Subject Auxiliary Electric Vacuum Pump Cover

Group 611.01.00 Date 02/08/2013

All Lamborghini Aventador LP 700 Coupe and Roadster MY 12 and 13 from VIN CLA0091 to VIN DLA01981.

1 Rubber cover (470 611 357)

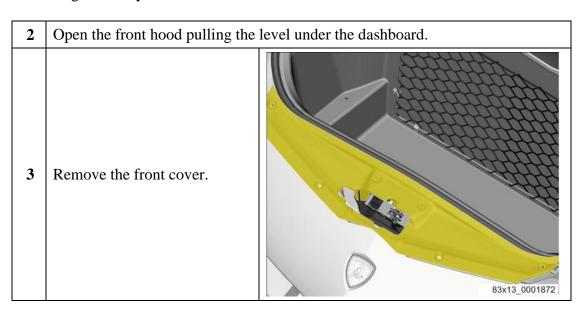
As a result of continuous product monitoring, Automobili Lamborghini Spa has found that on some vehicles the auxiliary electric vacuum pump may develop noise or limited function due to water ingress.

Install a cover onto auxiliary electrical auxiliary vacuum pump.

Make pass the connector through the rubber cover and install it onto the pump.
